**Environmental
Resources
Management**

24 January 2007

Subject: Former Arkema Portland Plant
Responses to ODEQ Comments on the Upland Remedial
Investigation Report, Lots 3 & 4 and Tract A
ECSI No. 398

Figure 2
Acetone Concentrations
Arkema Inc.
Portland, Oregon
 ERM 01/07

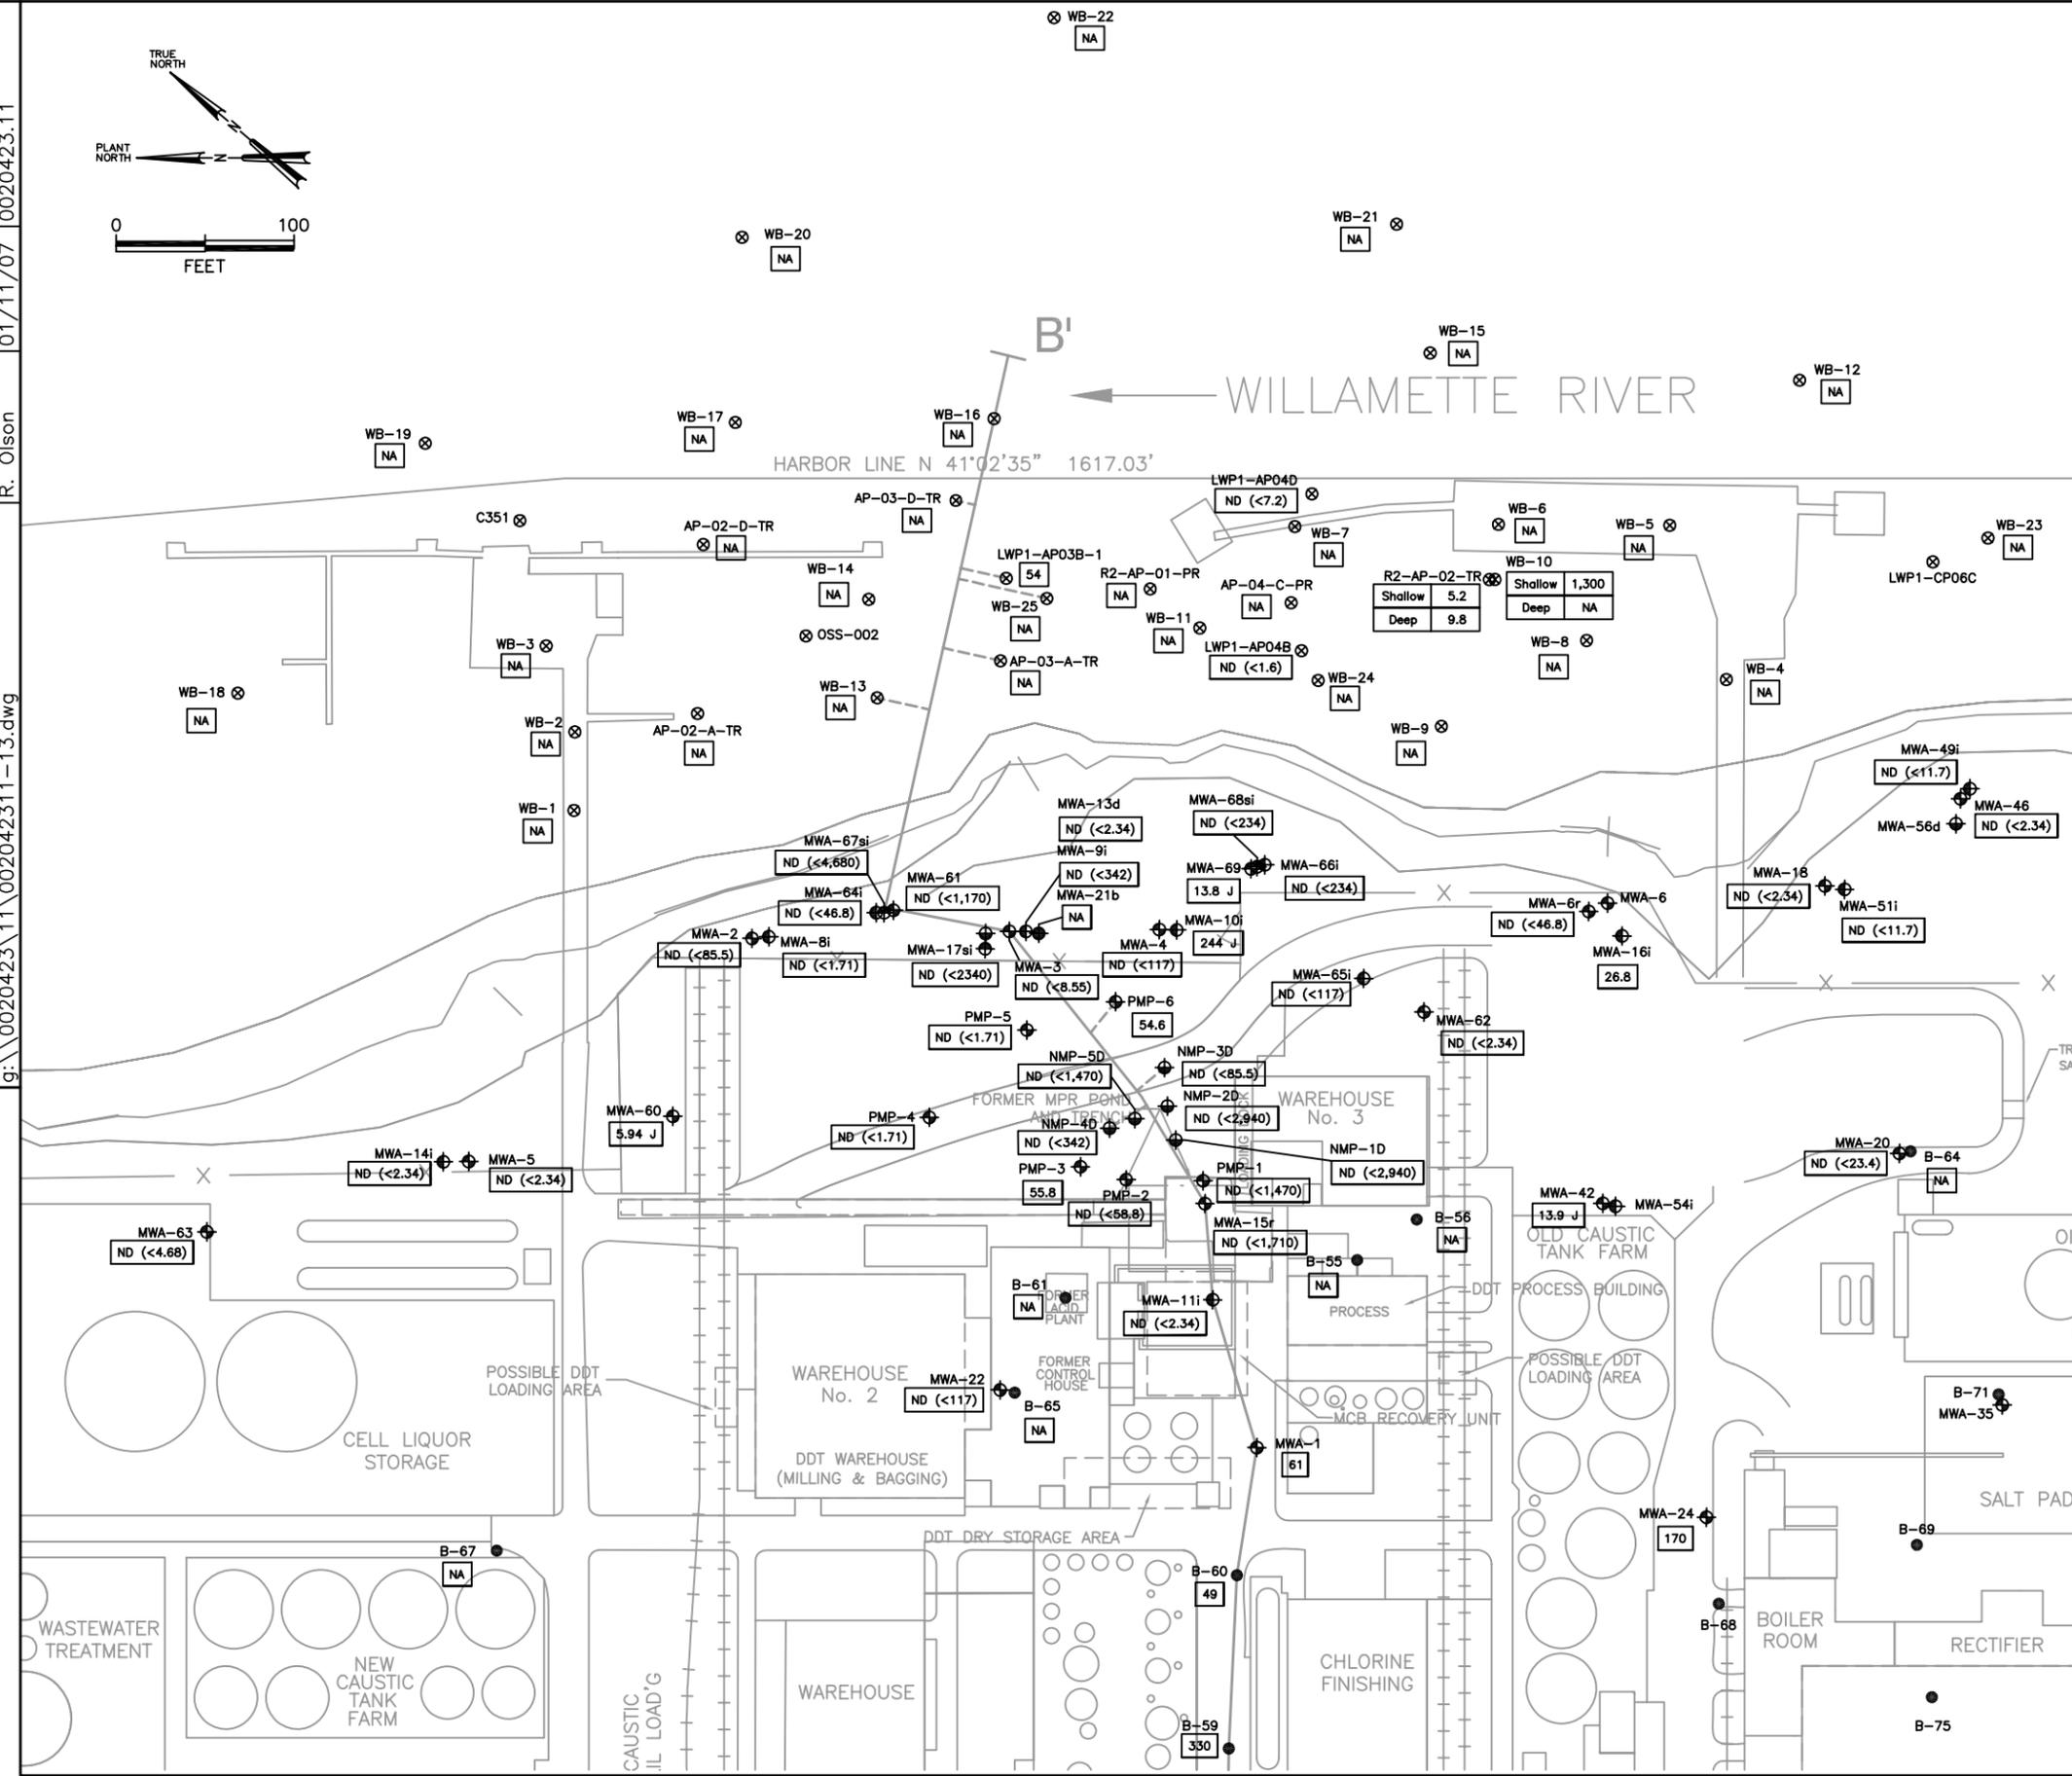
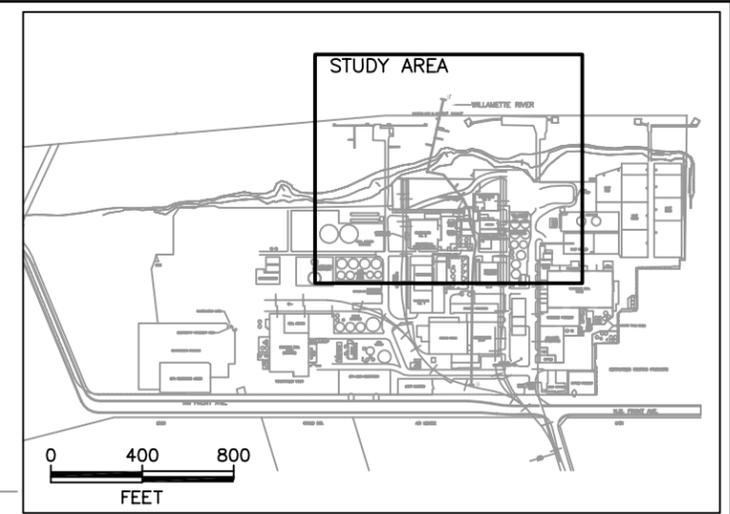
Comment 1 - The plan view figures prepared for acetone, carbon tetrachloride, chloroform, 1,2-dichlorobenzene, 1,3-dichlorobenzene, 1,4-dichlorobenzene, tetrachloroethene, 1,1,1-trichloroethane and trichloroethene did not include available Lower Willamette Group in-water data (LWG). Please update these figures to include the LWG sediment, groundwater and transition zone pore water data.

Lower Willamette Group (LWG) groundwater and transition zone data have been added to the figures as requested. Revised figures are included as Attachment A. Sediment data have not been included as these data are not directly comparable to dissolved phase groundwater and transition zone water data. The LWG data presented on the figures were obtained from:

Figure 7
 Cross Section B-B'
 Chloroform Concentrations
 Arkema Inc.
 Portland, Oregon

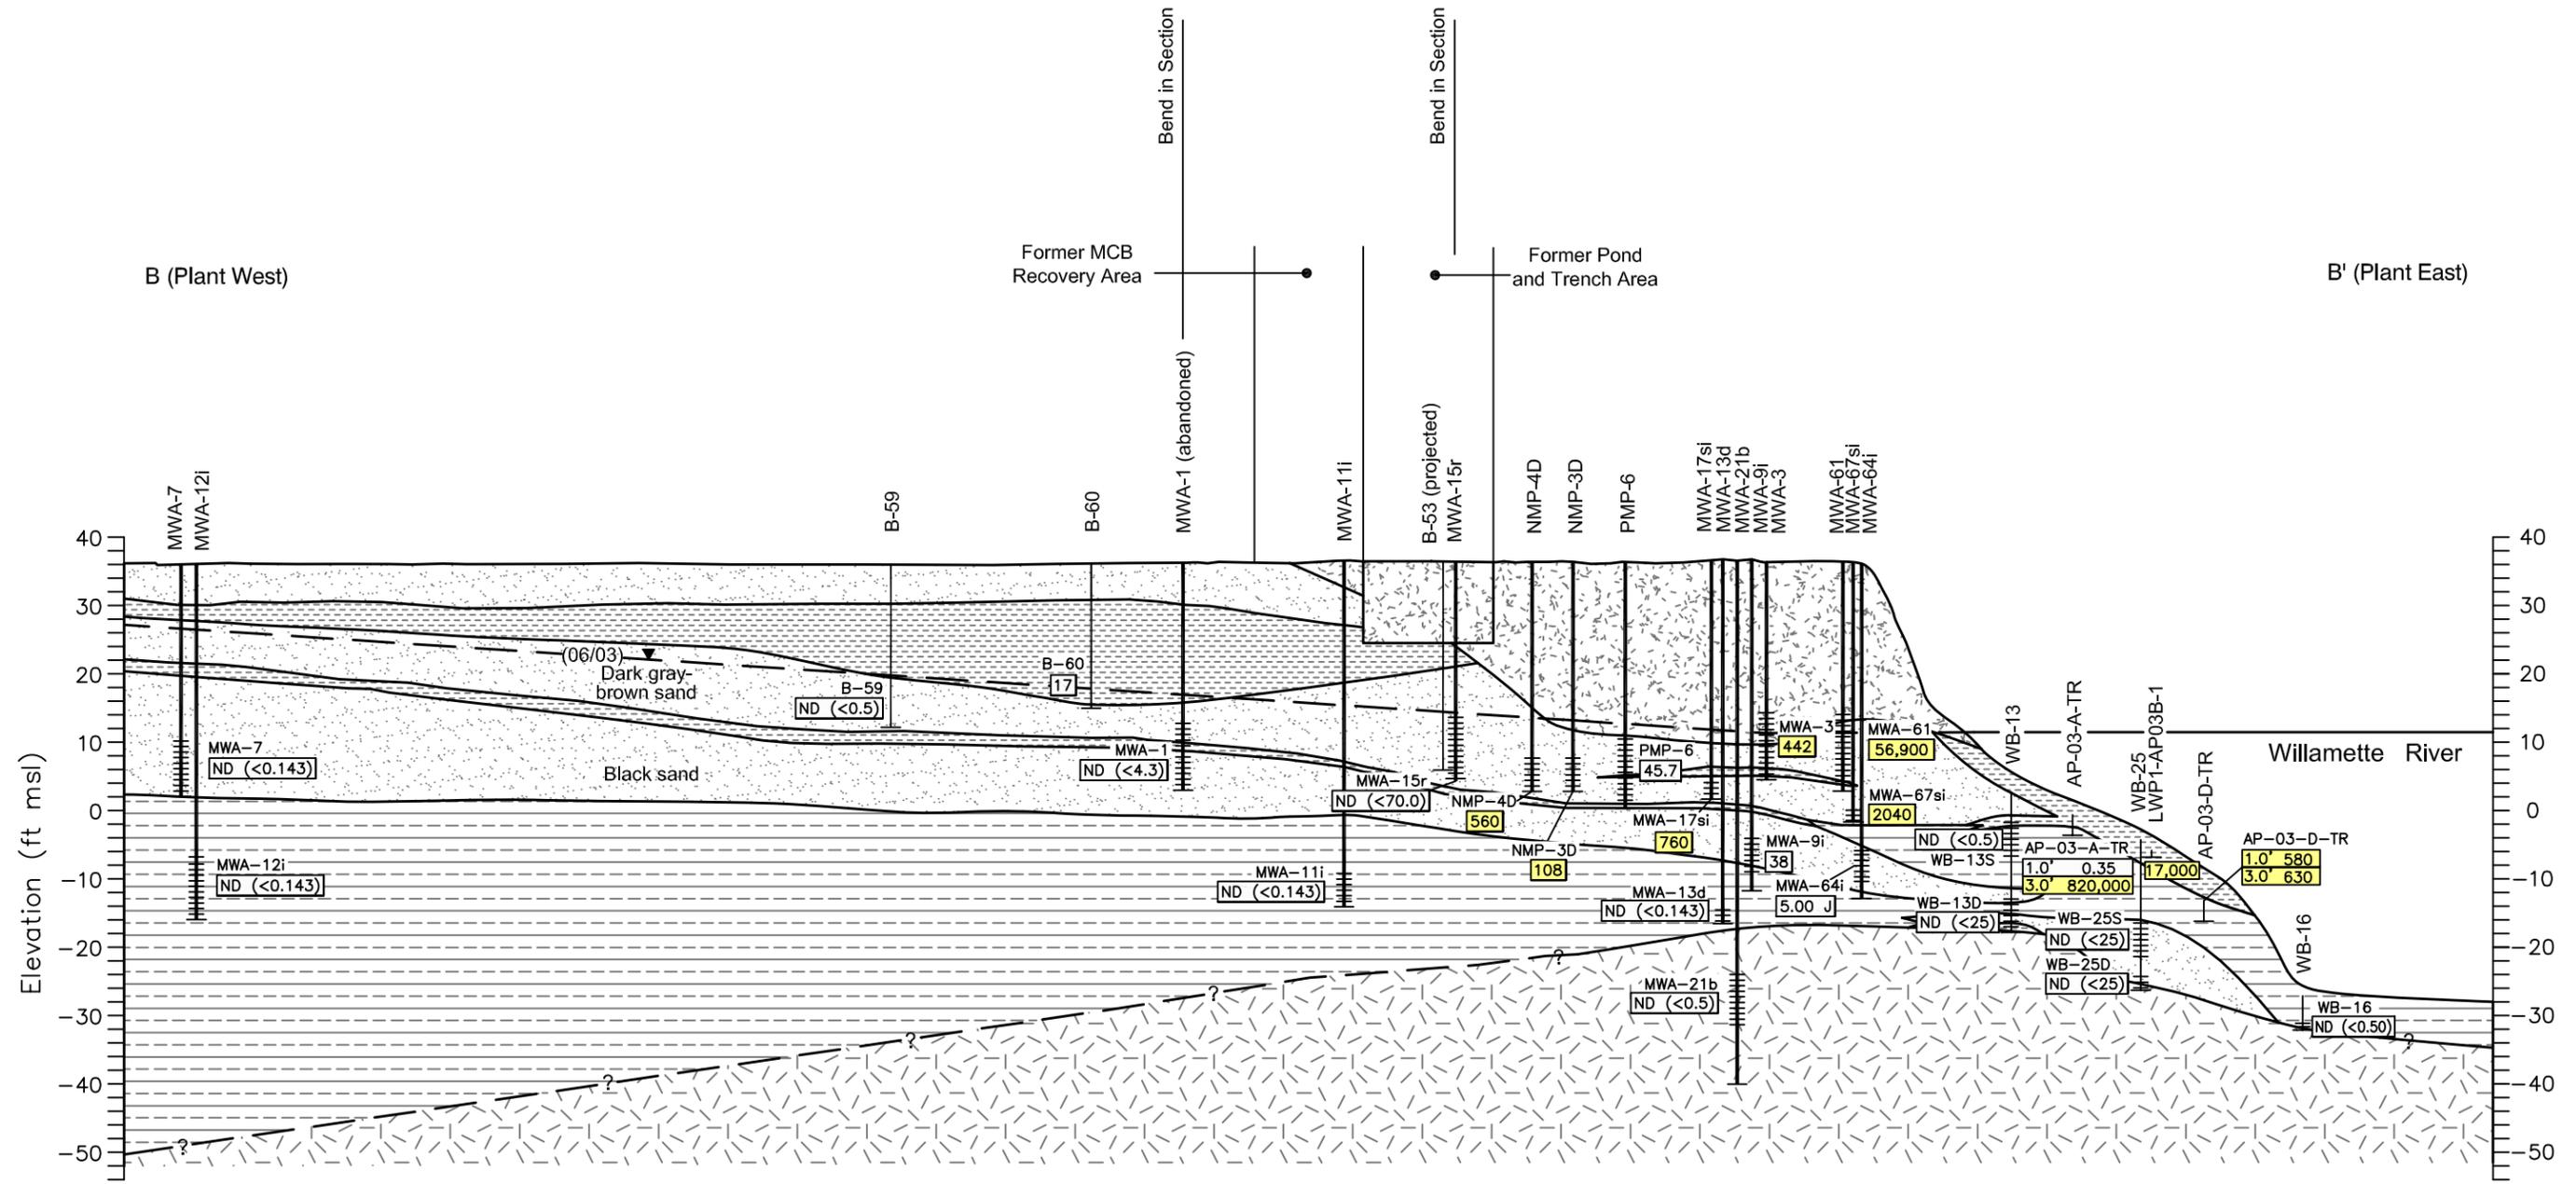
Comment 2 - The cross-sectional figures prepared for acetone, carbon tetrachloride, chloroform, 1,2-dichlorobenzene, 1-3-dichlorobenzene, 1,4-dichlorobenzene, tetrachloroethene, 1,1,1-trichloroethane and trichloroethene were not drawn through the monitoring well MWA-61 and MWA-67si locations. The unanticipated high levels of volatile organic compounds (VOC) detected in these two monitoring wells was the basis for DEQ's June 5, 2006 request that Arkema prepare additional summary figures of the VOC distribution to help illustrate the VOC distribution and potential source areas. DEQ requests that Arkema prepare new cross-sectional figures that illustrate the stratigraphy and VOC distribution upland and in-water at the MWA-61 and MWA-67si location. Relevant in-water data should be presented in the figures, and where the section alignment does not cross a relevant the in-water data point the in-water data should be projected onto the cross-section.

Revised cross-sectional figures depicting volatile organic compounds (VOCs) are attached. The cross-sectional figures have been revised to include wells MWA-61 and MWA-67si, as well as the in water data revealing the highest detections of VOCs.
